Access Compliance Report

Public Rights-of-Way

(Curb Ramps)

Intersection ID: 27679	Main Street: FOX_HEDGE_RD	Cross Street: HAMPSHIRE_HILL_RD	Location: SE
ADA ID: 5A7B111A7547	Ramp Type: Perp	Initial Pass/Fail: Fail	Overall Compliance: No
Severity Score: 25			
Codes/Mitigation Info/Possible Solution		Field Measurements/Component Compliance

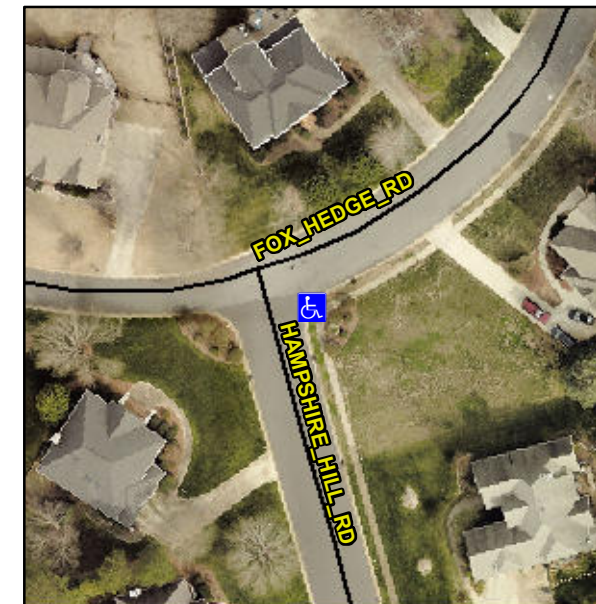
Not Found, R304.2.2

Compliance	Description	Data	Compliance	Description	Data
N/A	Ramp Length (in)	48.0	No	Ramp Slope (%)	15.4
Yes	Ramp Width (in)	48.0	Yes	Ramp XSlope (%)	0.2
N/A	Flare Type LT	N/A	N/A	Flare Type RT	N/A
N/A	Flare Slope LT (%)	N/A	N/A	Flare Slope RT (%)	N/A
N/A	Flare Traversable LT?	N/A	N/A	Flare Traversable RT?	N/A
N/A	Landing Length (in)	N/A	N/A	DWS Provided?	N/A
N/A	Landing Width (in)	N/A	N/A	DWS Contrast?	N/A
N/A	Landing Slope (%)	N/A	N/A	DWS Length (in)	N/A
N/A	Landing X Slope (%)	N/A	N/A	DWS Full Width?	N/A
N/A	Landing Curb? (Y/N)	N/A	N/A	DWS Offset (in)	N/A
N/A	Shared Landing?	N/A			
N/A	Gutter Ponding?	N/A	N/A	Gutter Slope (%)	N/A
N/A	Gutter Lip Ht (in)	N/A	N/A	Gutter X Slope (%)	N/A
N/A	Painted X Walk1?	No	N/A	Painted X Walk2?	N/A
	X Walk 1 Direction	To W		X Walk 2 Direction	N/A
N/A	X Walk 1 Width (in)	N/A	N/A	X Walk 2 Width (in)	N/A
	X Walk 1 Slope (%)	2.0		X Walk 2 Slope (%)	N/A
	X Walk 1 X Slope (%)	1.2		X Walk 2 X Slope (%)	N/A

Remove & Replace Entire Ramp.
